Access Compliance Report

Public Rights-of-Way

(Curb Ramps)

Intersection ID: 2923	Main Street: DOWNFIELD_WOOD_DR	Cross Street: REDSTART_CT	Location: NW
ADA ID: 15D497FFABD3	Ramp Type: PerpDiag	Initial Pass/Fail: Fail	Overall Compliance: No
Severity Score: 8.75			
Codes/Mitigation Info/Possible Solution		Field Measurements/Component Compliance

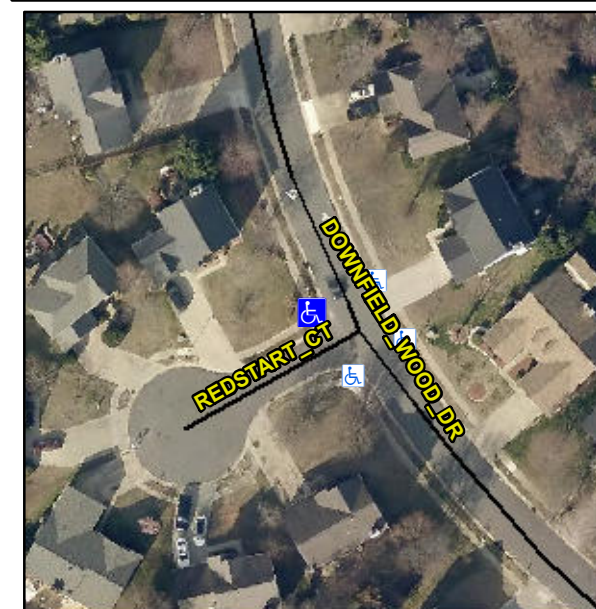
Not Found, R304.5.1

Compliance	Description	Data	Compliance	Description	Data
N/A	Ramp Length (in)	49.0	Yes	Ramp Slope (%)	6.7
No	Ramp Width (in)	47.0	Yes	Ramp XSlope (%)	1.0
N/A	Flare Type LT	N/A	N/A	Flare Type RT	N/A
N/A	Flare Slope LT (%)	N/A	N/A	Flare Slope RT (%)	N/A
N/A	Flare Traversable LT?	N/A	N/A	Flare Traversable RT?	N/A
N/A	Landing Length (in)	N/A	N/A	DWS Provided?	N/A
N/A	Landing Width (in)	N/A	N/A	DWS Contrast?	N/A
N/A	Landing Slope (%)	N/A	N/A	DWS Length (in)	N/A
N/A	Landing X Slope (%)	N/A	N/A	DWS Full Width?	N/A
N/A	Landing Curb? (Y/N)	N/A	N/A	DWS Offset (in)	N/A
N/A	Shared Landing?	N/A			
N/A	Gutter Ponding?	N/A	N/A	Gutter Slope (%)	N/A
N/A	Gutter Lip Ht (in)	N/A	N/A	Gutter X Slope (%)	N/A
N/A	Painted X Walk1?	No	N/A	Painted X Walk2?	No
	X Walk 1 Direction	To S		X Walk 2 Direction	To E
N/A	X Walk 1 Width (in)	N/A	N/A	X Walk 2 Width (in)	N/A
	X Walk 1 Slope (%)	0.9		X Walk 2 Slope (%)	1.1
	X Walk 1 X Slope (%)	1.5		X Walk 2 X Slope (%)	1.5

Remove & Replace Curb Ramp With Two New Directional Ramps or Equivalent.
